APPLICATION NO.	FILING DATE	FIRST NAMED INVENTOR	ATTORNEY DOCKET NO.	CONFIRMATION NO.
10/595,441	04/19/2006	Pierre Beteille	171.004	9671

Office Action Summary	Application No. 10/595,441	Applicant(s) BETEILLE, PIERRE	
	Examiner Erica E. Cadugan	Art Unit 3722

DETAILED ACTION

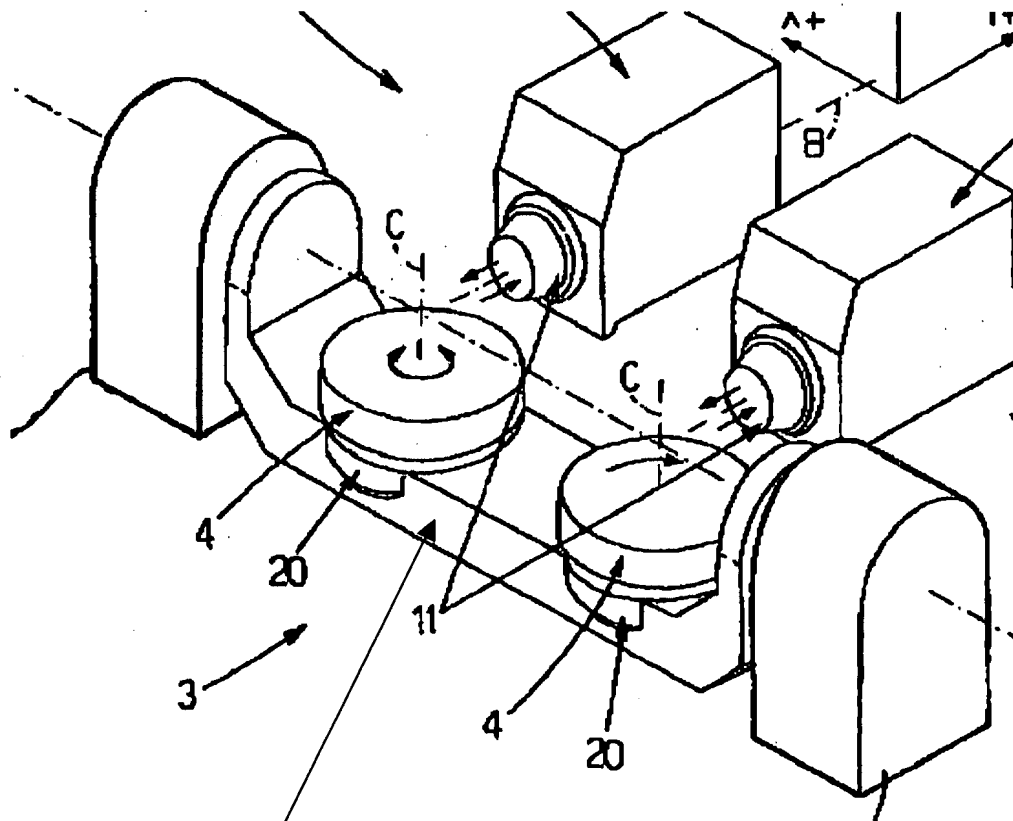
Re claim 3, see the partial reproduction of Figure 4 labeled below, and also note that platforms 4 can be considered “receiving plates” as broadly claimed.

Example of a portion of the table 3
that can be considered a
“rigidification beam”

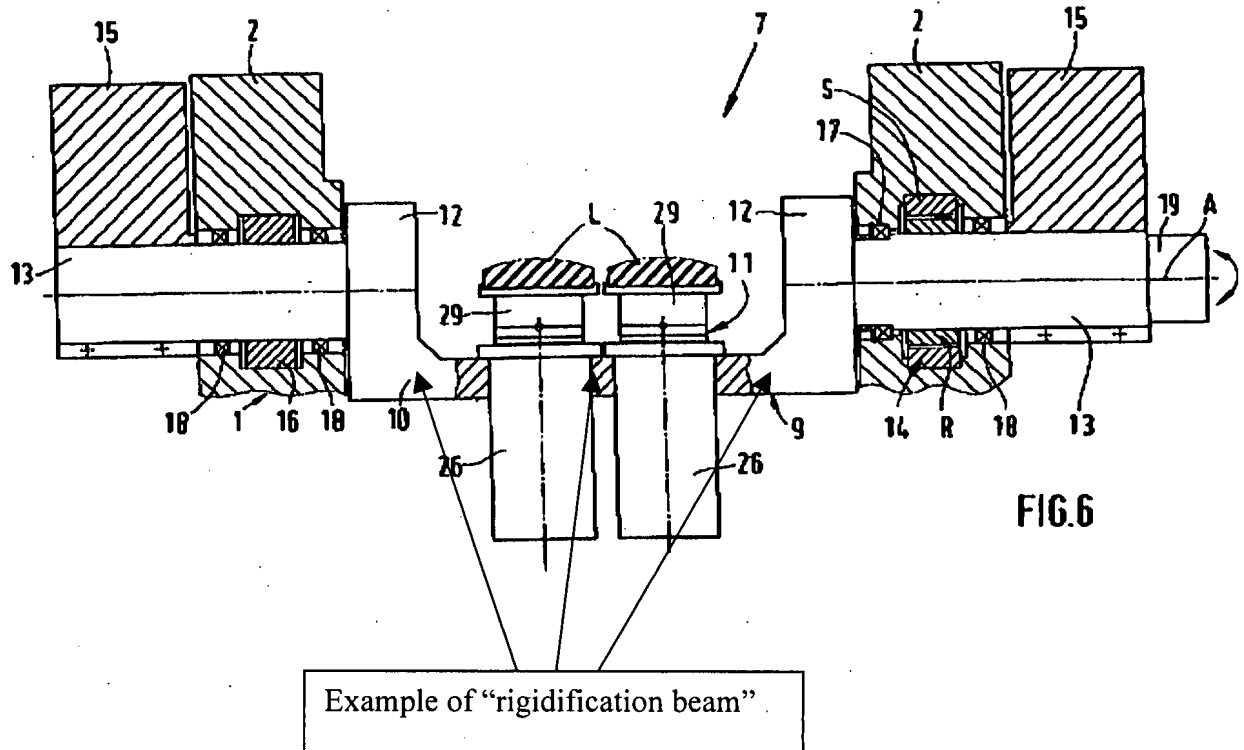
Re claim 3, see the reproduction of Figure 6 below, noting that the upper portion of element 29 can be considered a “receiving plate”, for example.
